REF: 22/00489/F

Location: Os Parcel 9078 And 9975 Adjoining Stocking Lane

Holding Objection

Public Open Space

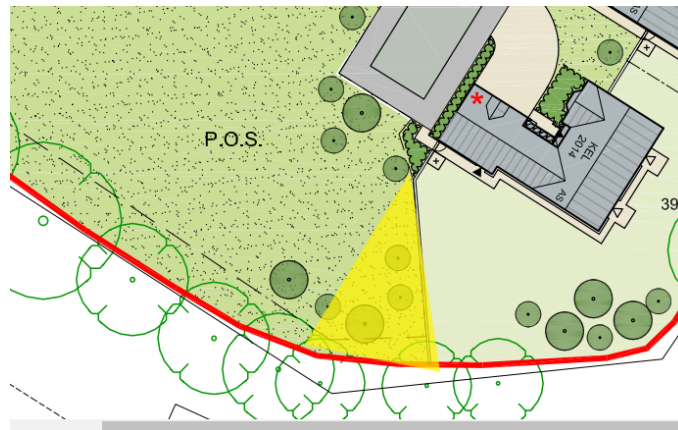
- Areas of POS/play should be designed and located to incorporate a high level of natural surveillance from neighbouring dwellings. The occupants of these dwellings could act as capable guardians to play areas, but need to be able to observe the area from active rooms in the dwellings to do so effectively. Clear stem trees (clear to 2m), and hedging maintained below 1m should be used in the planting to facilitate clear sightlines. Areas of green space adjoining the highway must also have sufficient landscaping and/or design features to prevent unauthorised vehicle incursion, to protect them from illegal encampments.

- The recessed area between plot 27/28 should be enclosed within the boundary of these plots, or secured via deep defensible space and planting.
- The side boundary of plot 39 adjoining the POS is particularly vulnerable as it lacks defensible space, whilst adjoining an easily accessible recessed area of POS with poor surveillance covering it. As previously mentioned it is vital that these boundaries are sufficiently protected. Additionally, tree planting must be located a sufficient distance from dwelling boundaries to prevent them being used as a climbing aid. I recommend this space is reconfigured to remove the recessed area and improve surveillance over this area:
